ADDENDUM 2 – JOB 23550

TO: All prospective bidders on Projects BRP-BRJ-0006(052), Job No. 23550 scheduled for the February 7, 2025 bid opening.

PROJECT INFORMATION		
Project:	BRP-BRJ-0006(052)	PCN: 23550
Location:	17 Miles South and 3 Miles East of Marmarth, ND	
Date:	2/05/2025	Lead Designer: Lucas Doerr
Bid Opening Date:	02/07/2025	JOB#: 23550 Addendum#: 2

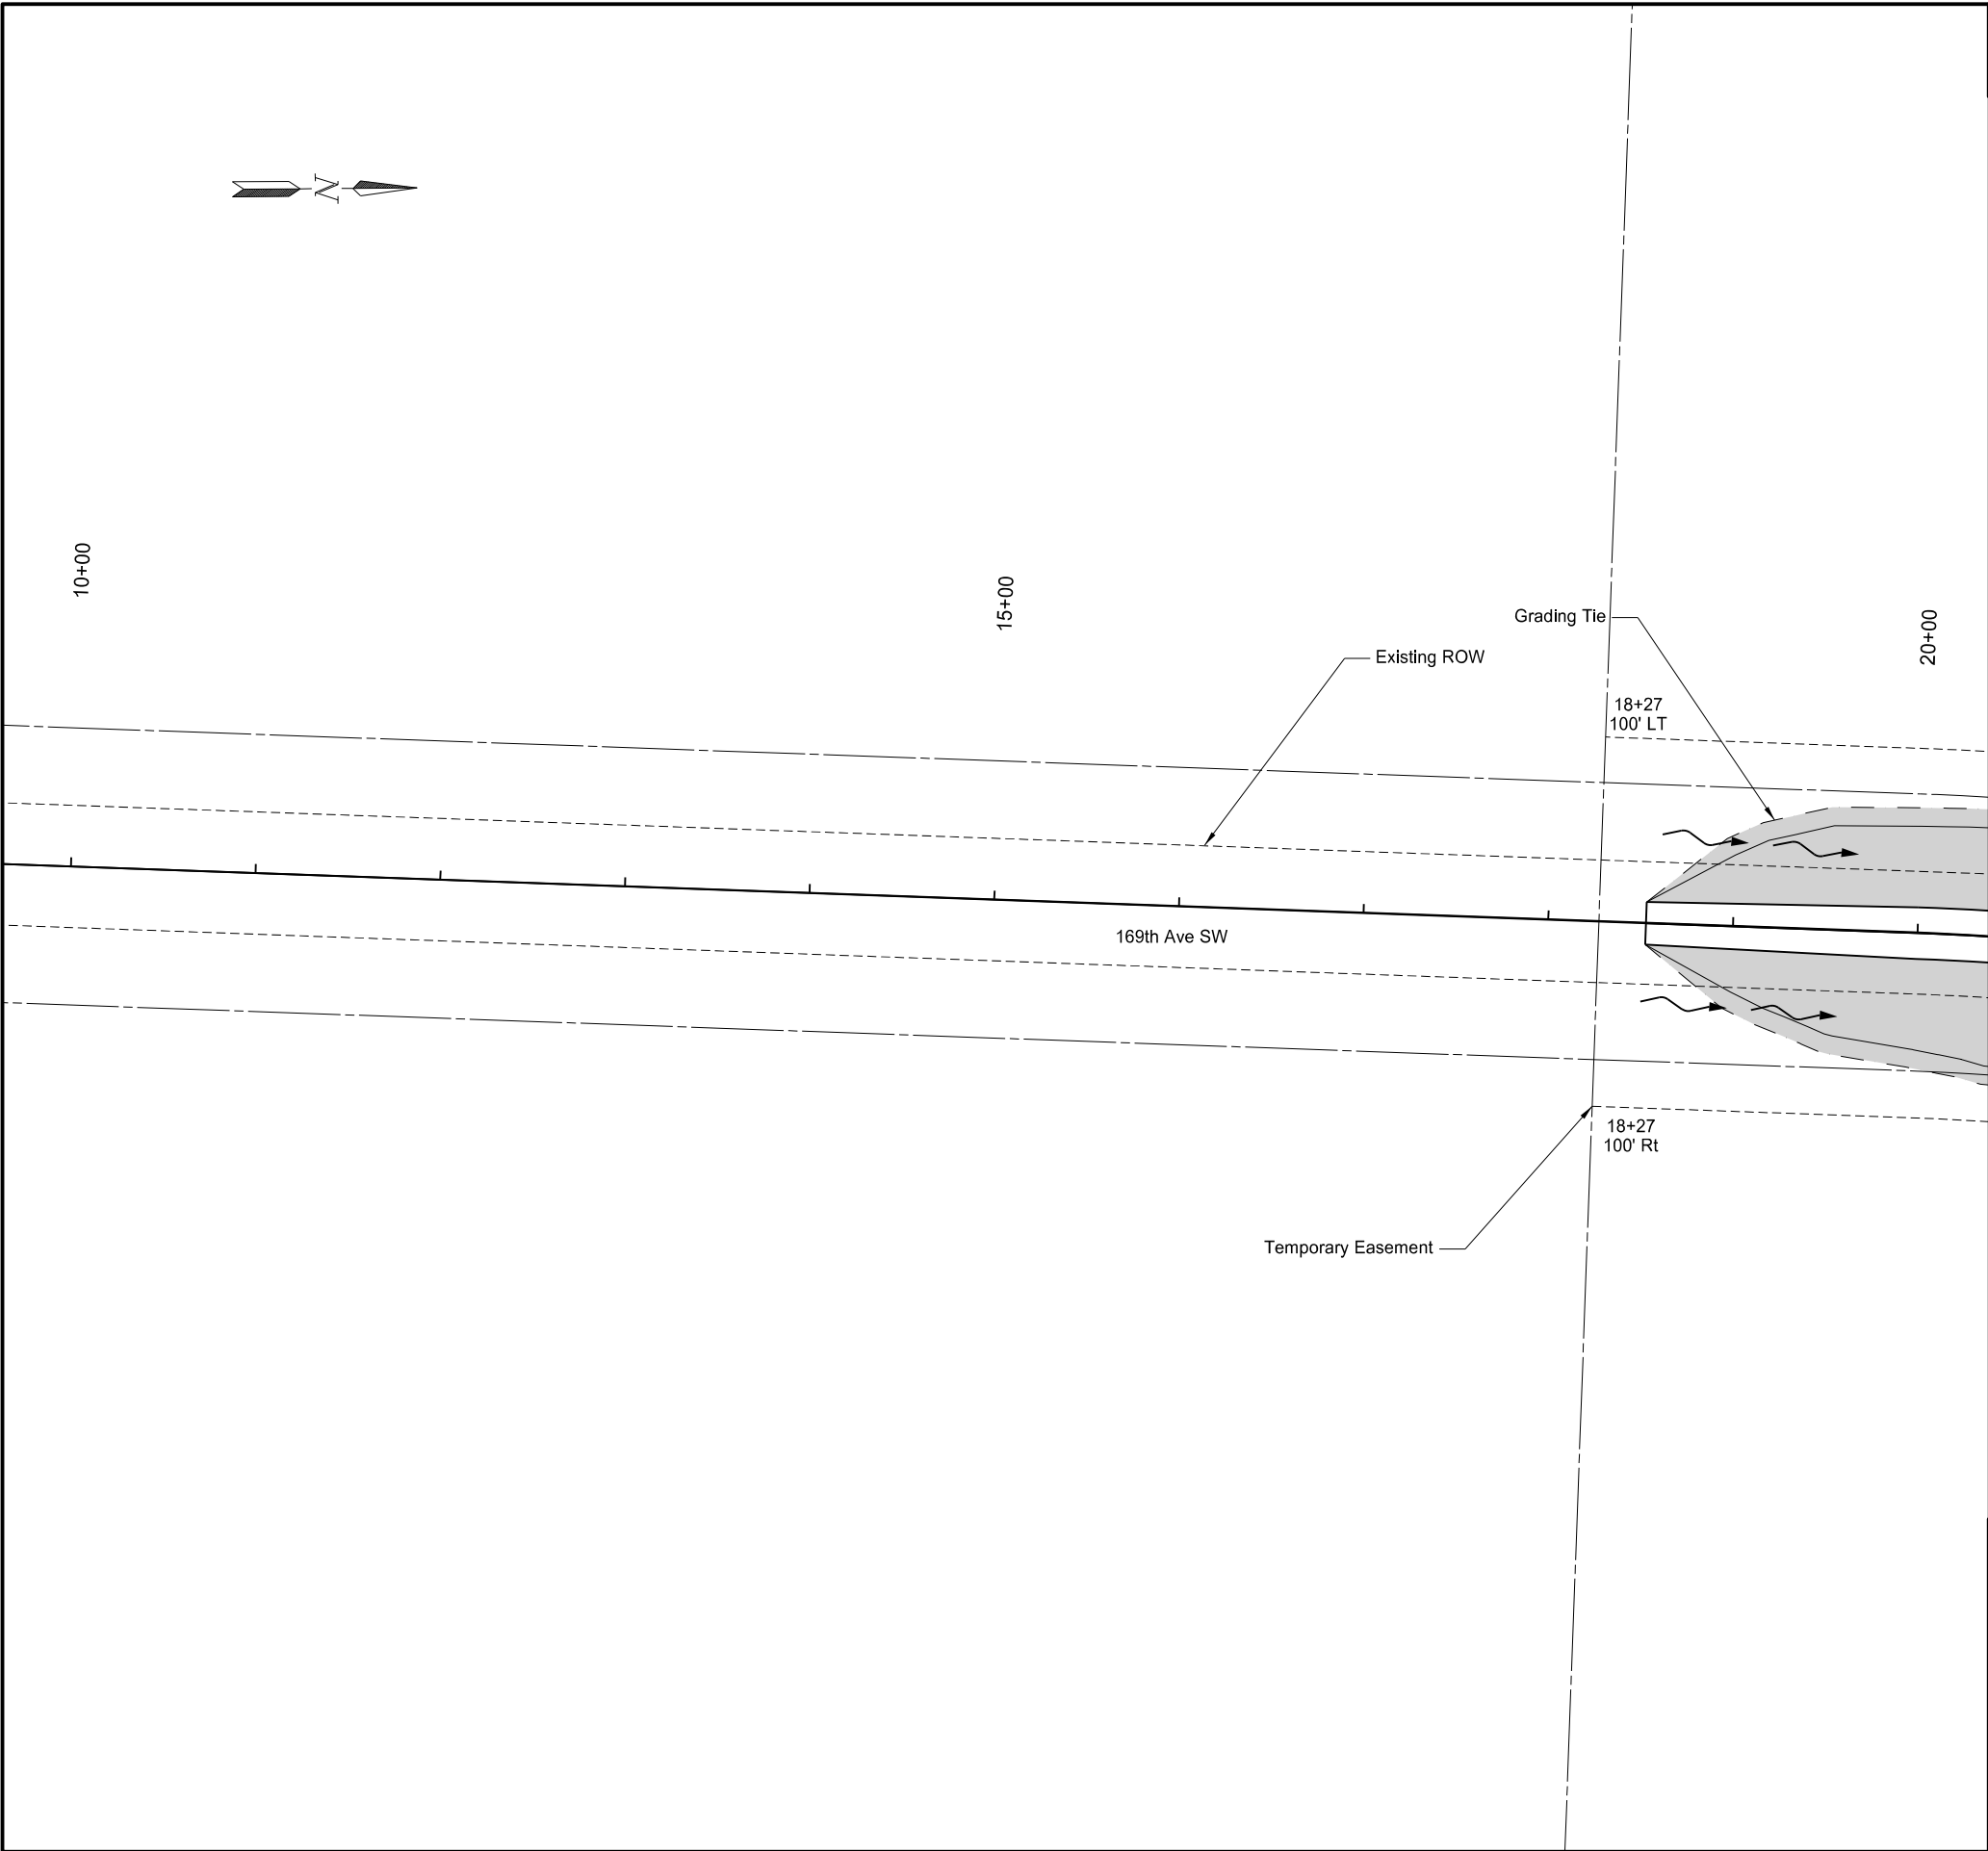
PLAN SHEET CHANGES		
Section	Sheet	Description
76	8	Modified the header of the "Ditch Fiber Rolls" tables to specify "Fiber Rolls 20" (LF)"
77	1	Modified the legend to specify Fiber Rolls 12"
77	2	Modified the legend to specify Fiber Rolls 12"
77	3	Modified the legend to specify Fiber Rolls 12"
77	4	Modified the legend to specify Fiber Rolls 12"
77	5	Modified the legend to specify Fiber Rolls 12"
